Addendum No. 2

Project: Fort Wayne International Airport
Construct Taxiway G Extension & Demolish Taxiway C2
AIP No. 3-18-0022-XX

Date: June 20, 2024

Drawing No.: **G5.1.4**

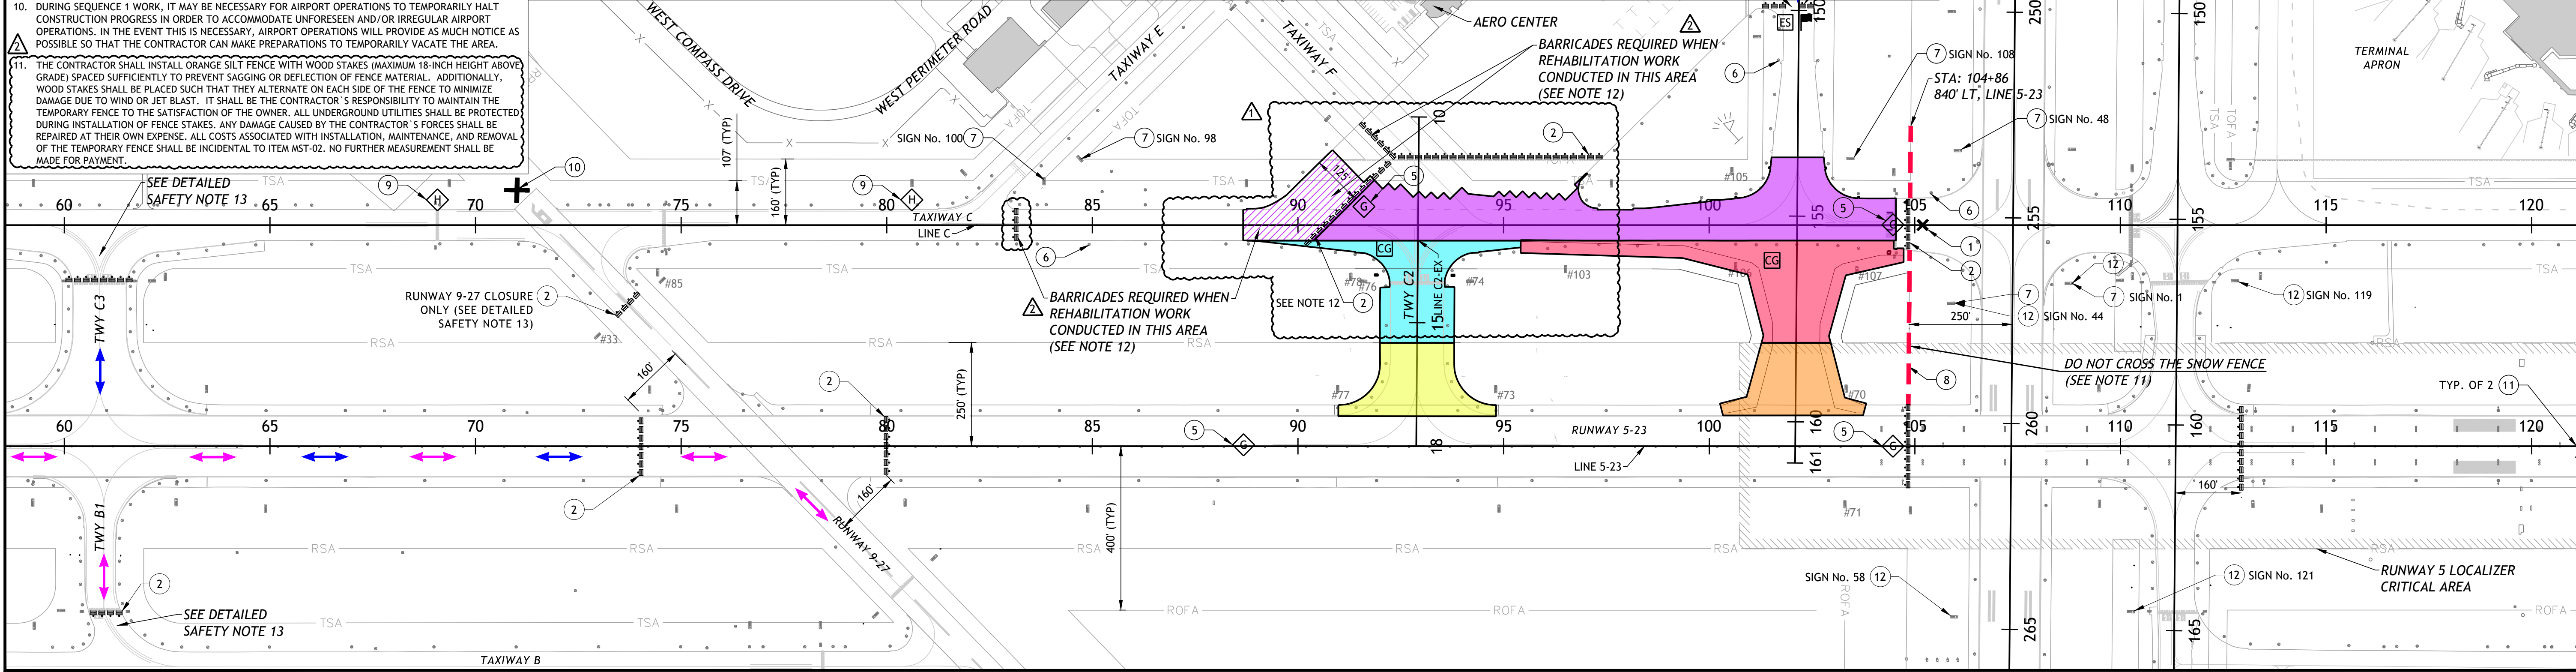
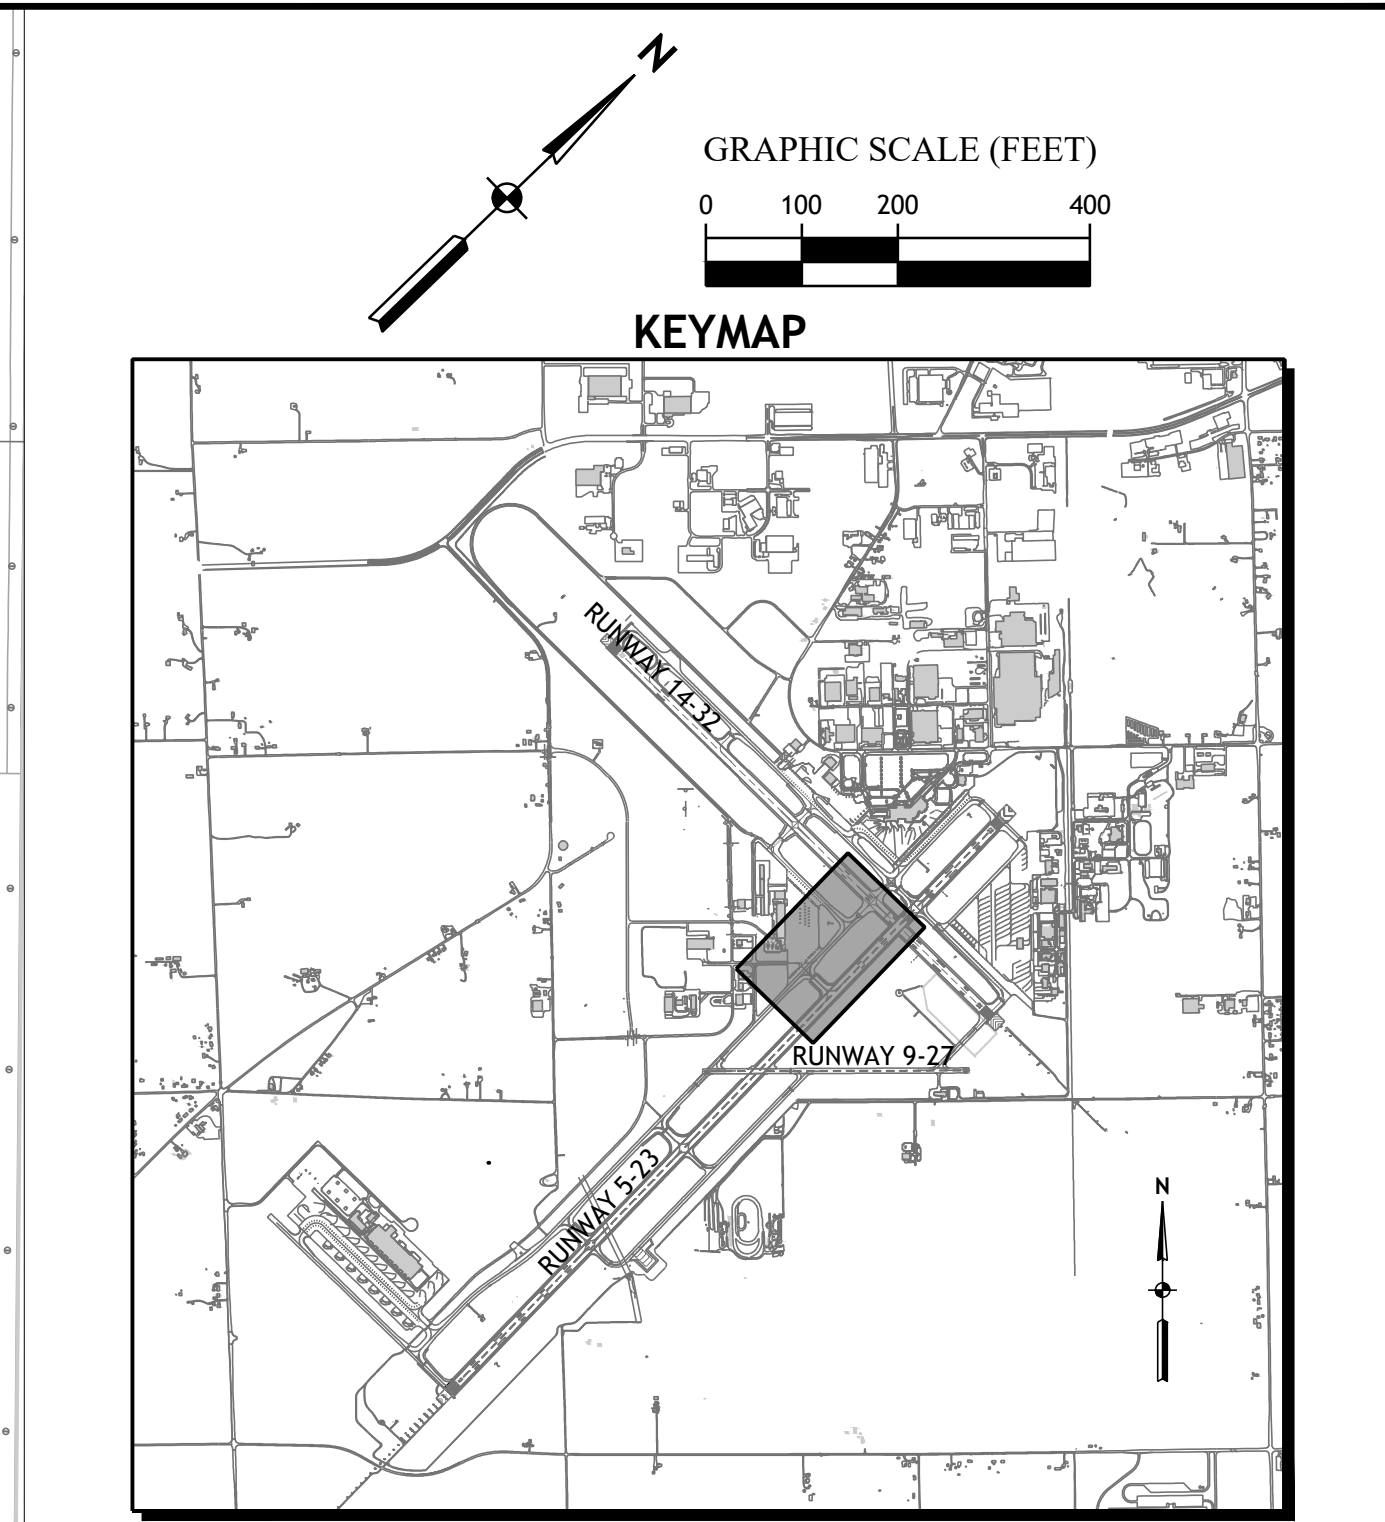
Reissued: The sheet number has been revised from G5.1.3 to new sheet G5.1.4 to account for addition of new Sheet G5.1.2 as described above. Additional information also reflected for Additive Alternate No. 3 and other associated updates.

Drawing No.: **C4.1.1**

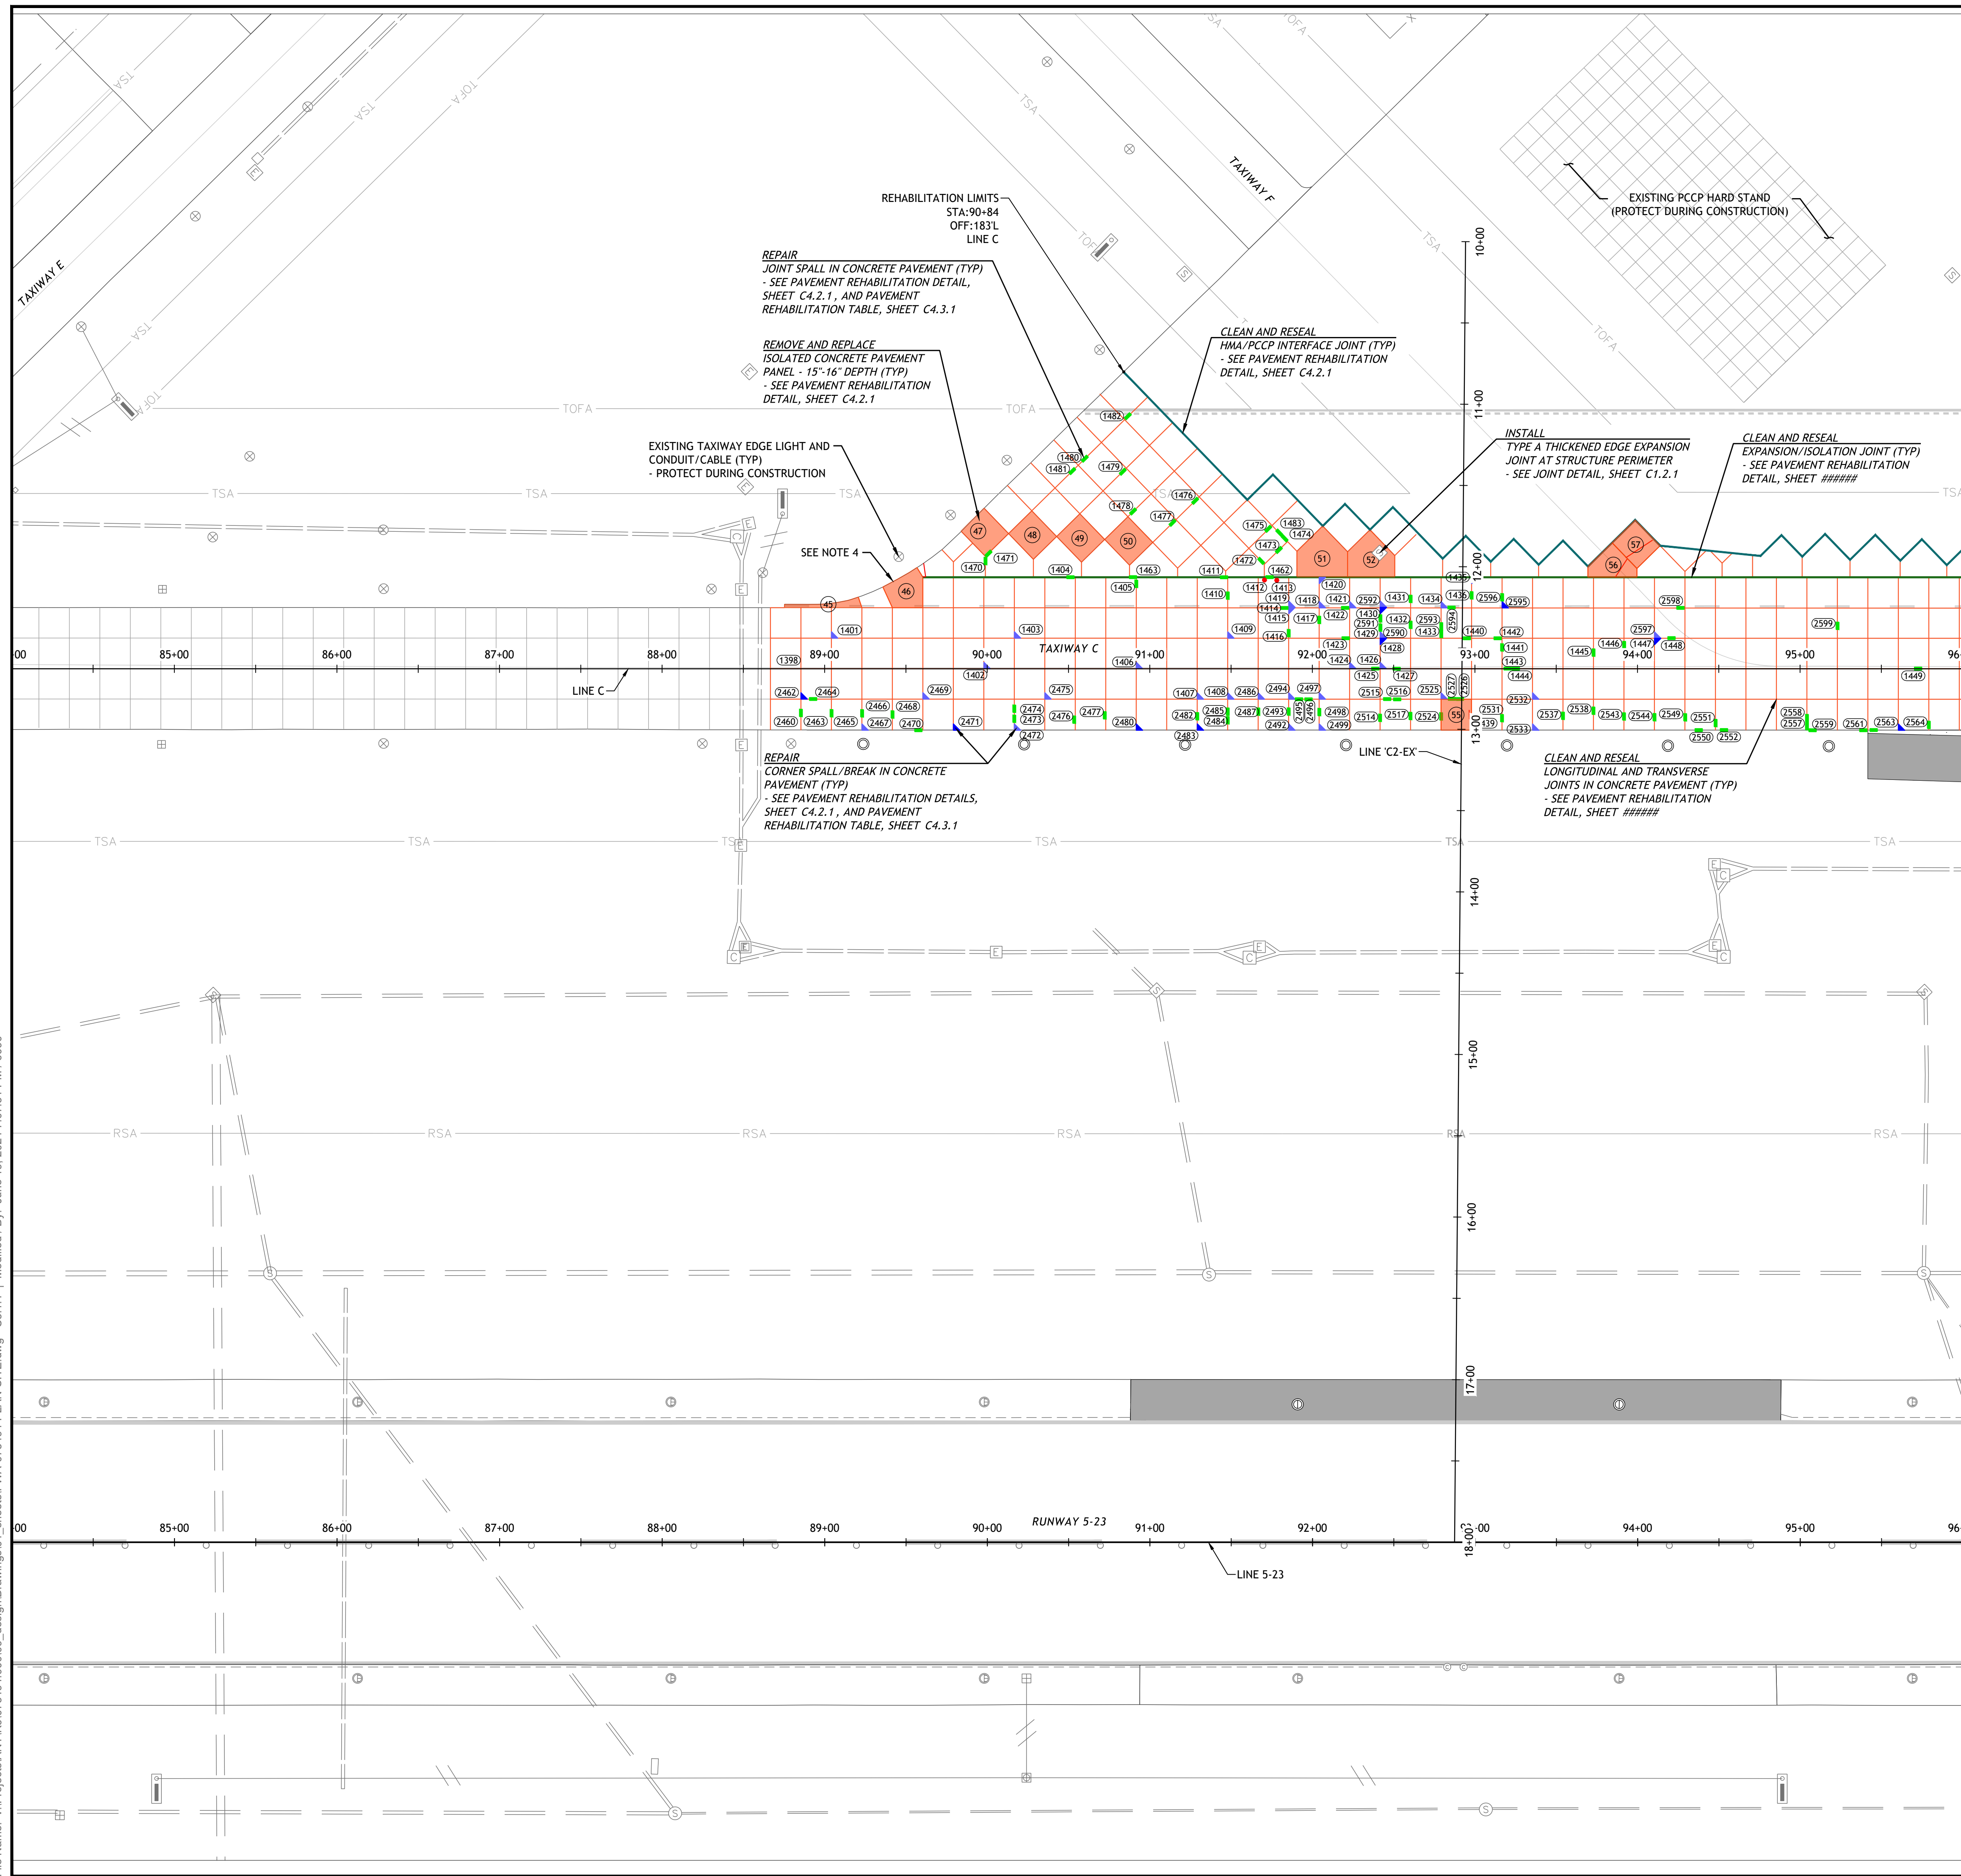
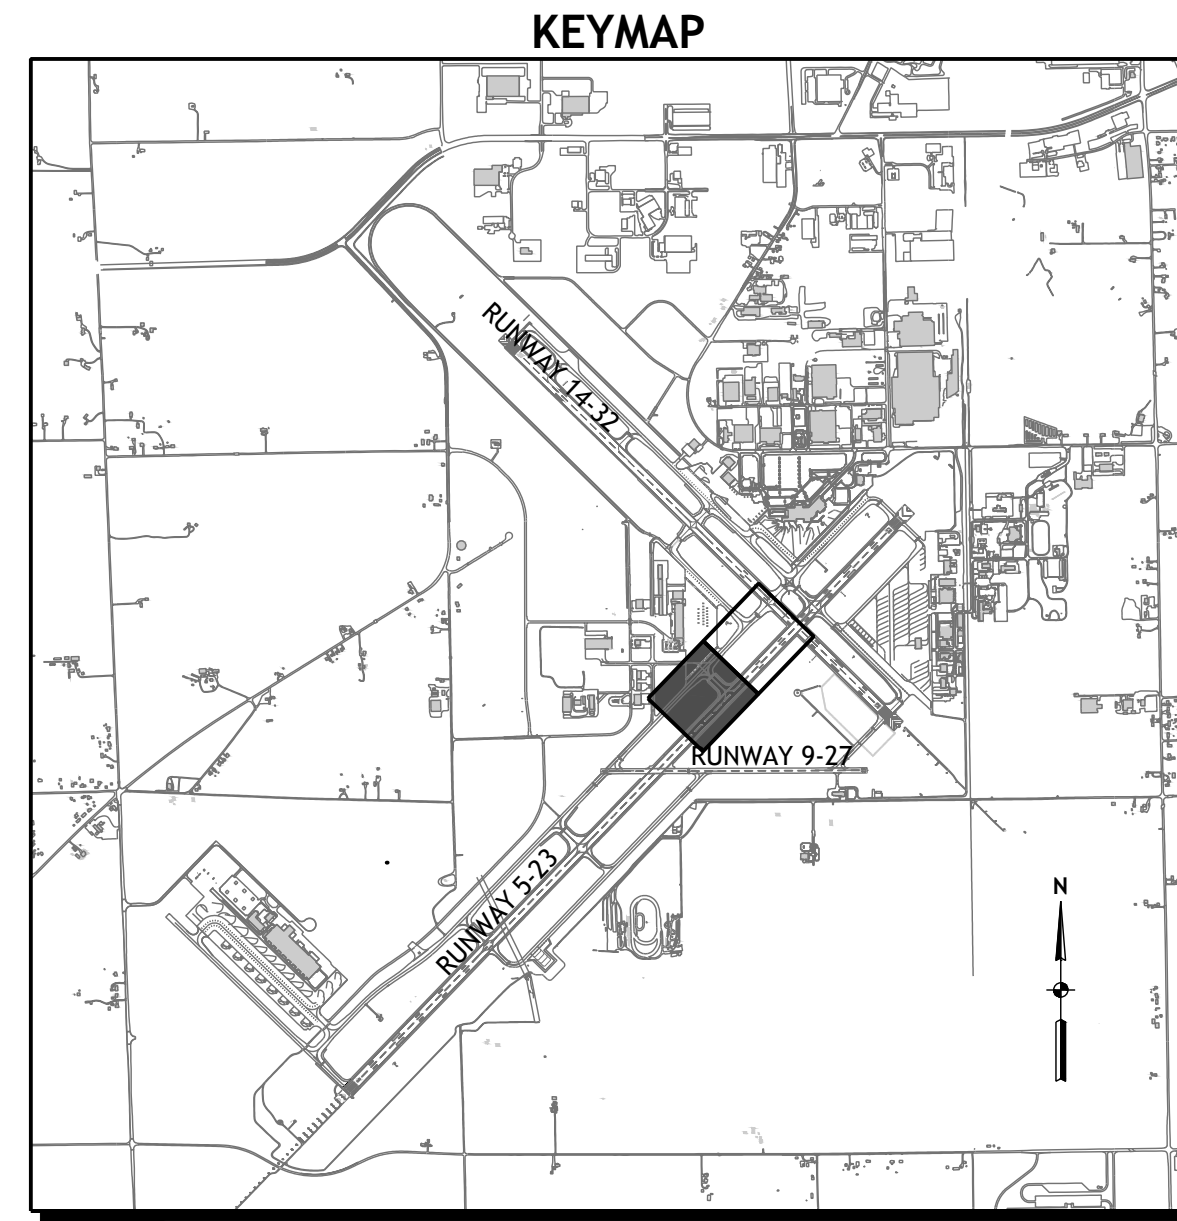
Issued: New sheet has been added to reflect proposed pavement repairs to Taxiway C between the West Apron and Runway 14-32.
